Product Change Notice (PCN)

PCN Number: PCN-0450011R-01

Product(s) Affected: PJ-069B-SMT-TR

Description of Change: *Materials and packaging update*

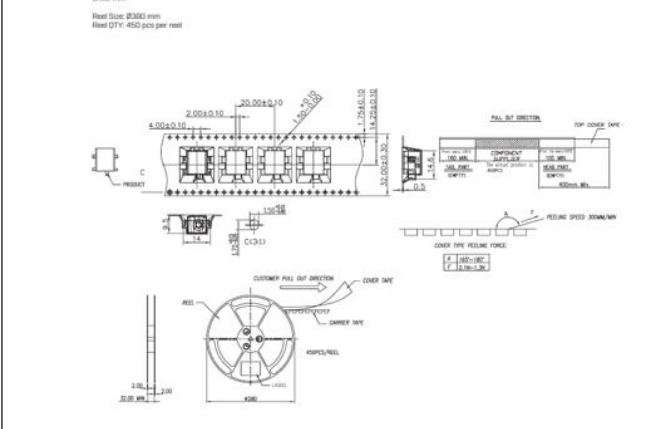
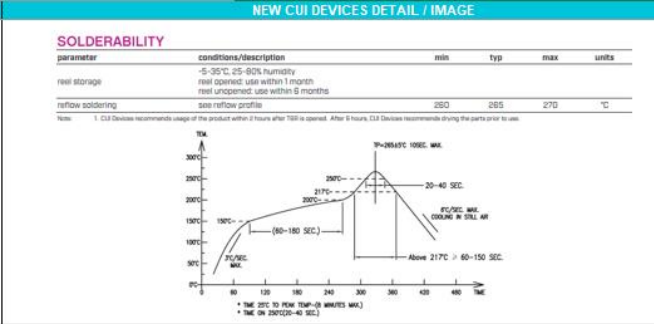
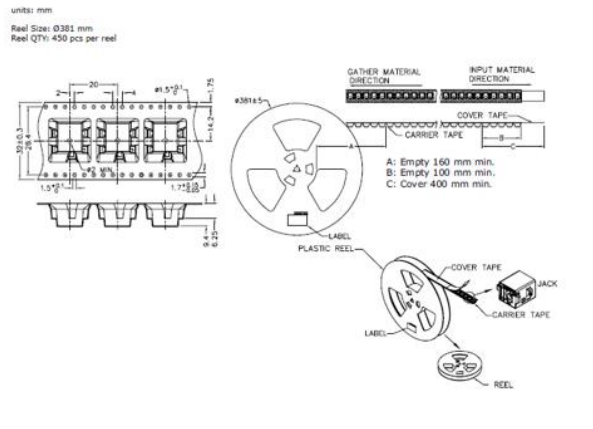
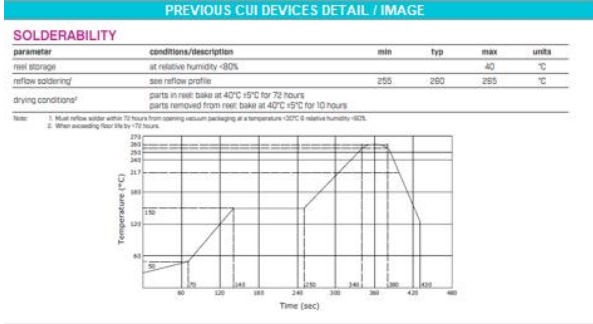
MATERIAL	PLATING																																																							
center pin	brass	nickel																																																							
terminal 1	brass	silver																																																							
terminal 2	copper alloy	silver																																																							
terminal 3	brass	silver																																																							
shield-A	brass	nickel																																																							
shield-B	stainless steel																																																								
plastic	PA6T or equivalent																																																								
	DESCRIPTION	MATERIAL	PLATING/COLOR																																																						
center pin		copper	nickel																																																						
terminal 1		brass	silver																																																						
terminal 2		copper alloy	silver

terminal 3		brass	silver																																																						
shield-A		brass	nickel																																																						
shield-B		stainless steel																																																							
housing		PA10T (UL94V-0)	black																																																						
 <p>MATING PLUG Jack Insertion Depth: 8.2 mm</p>	 <p>MATING PLUG Jack Insertion Depth: 8.3 mm</p>
